**NRC Feedback on “KHNP’s Draft Revised Response to RAI 129-8085, Question 3.8.1-1”
(Draft Response Provide 2/19/16)**

The staff evaluated the draft response to Question 3.8.1-1 and noted the following:

Figure 1. Locations for Transient Displacement (Hydrodynamic Load, Time History Analysis)

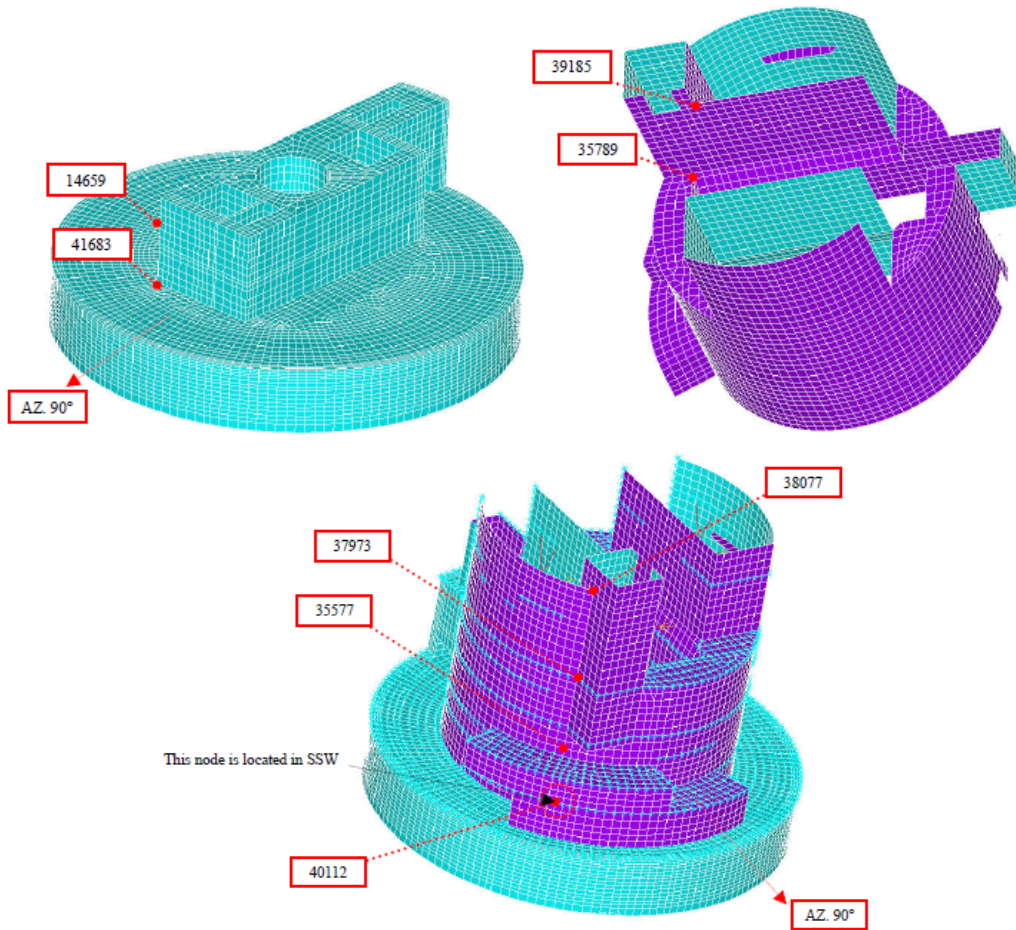
e. The first paragraph of the RAI response states “Thus, there is no connection to transfer POSRV actuation loads to the containment wall. Therefore, POSRV actuation loads are not applied to the containment basemat through the containment wall.” Since the POSRV loads also apply a pressure load on the IRWST floor slab which is on top of the RCB basemat, then POSRV loads can affect the RCB basemat directly (i.e., not through the containment wall) and also may have an effect on the dynamic overall building response in terms of member forces and building response spectra. The basis for not considering these effects should be provided or an evaluation should be performed to consider these loads.

The remaining paragraphs of the response, including the response to Question 03.08.03-1 of RAI No. 208-8245, do not adequately demonstrate that there will be no overall building response in terms of member forces and building response spectra. The RAI response indicates that the hydrodynamic pressure load is a short transient pressure time history, the period of the POSRV discharge load is very short, and the load rapidly decreases in magnitude. This type of hydrodynamic pressure time history is similar to safety relief valve transients in other nuclear power plants which have shown in some cases to cause significant loading on the overall building response and response spectra. Therefore, the applicant is requested to provide further justification to address this item.

With regard to the dynamic overall building response caused by POSRV loads, the additional hydrodynamic load analysis, which is time history analysis (refer to Table 1 of Question 03.08.01-15 of RAI No. 249-8323), has been carried out. In this analysis, the transient displacements of primary and secondary shield wall (PSW and SSW), which will be directly influenced on POSRV load because of entire structure (PSW, SSW, IRWST), were calculated. The locations for transient displacement were selected within the influence region of POSRV loading as shown in Figure 1. The maximum transient displacements of PSW and SSW are also described in Table 1. As shown in Table 1, on every direction, the maximum transient displacement is less than 0.0036 inch (0.091 mm). Figure 2 shows the Floor Response Spectrum (FRS) of PSW (EL. 100'-0", EW) by POSRV load. And the comparison of spectral acceleration between POSRV and seismic (SSE) loads (EL. 100'-0") is shown in Table 2. The spectral acceleration by POSRV is less than 9 percent of that by seismic load. Therefore, it can be judgeable that the structure response caused by POSRV load is negligible to overall building except for local design of IRWST wall for POSRV pressure load.
